## Product Change Notification

**1. ECR #:** 218758  
**Notification #:** 655

**2. Date of Announcement:** November 09, 2022

- IPL1-1XX-XX-XXX-SH-K-XX - null
- IPL1-XX-SH - null

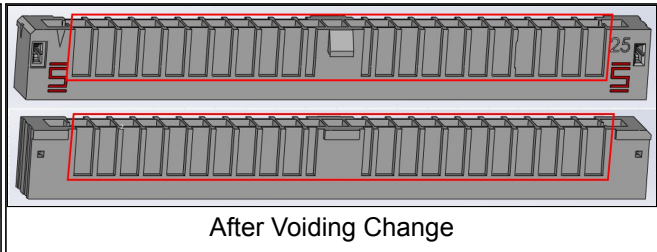
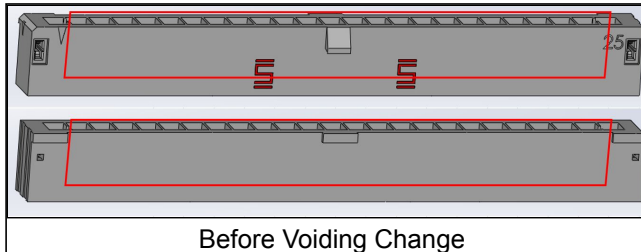
Added voids on both non-mating sides of body. Existing connectors side walls were smooth. There were no other changes except for adding the voiding to sides of connector body. These voids will be present on IPL1 -SH bodies from position 6 up to and including 25.

- Form - Non-mating side wall voids were added to improve the manufacturability. These will be implemented for positions 6 up to and including 25.
- Fit - No change to the fit. These changes are backward compatible with Samtec's IPD1/MMSS connectors.
- Function - Changes to mechanical and electrical integrity have been evaluated and no detrimental changes were found.
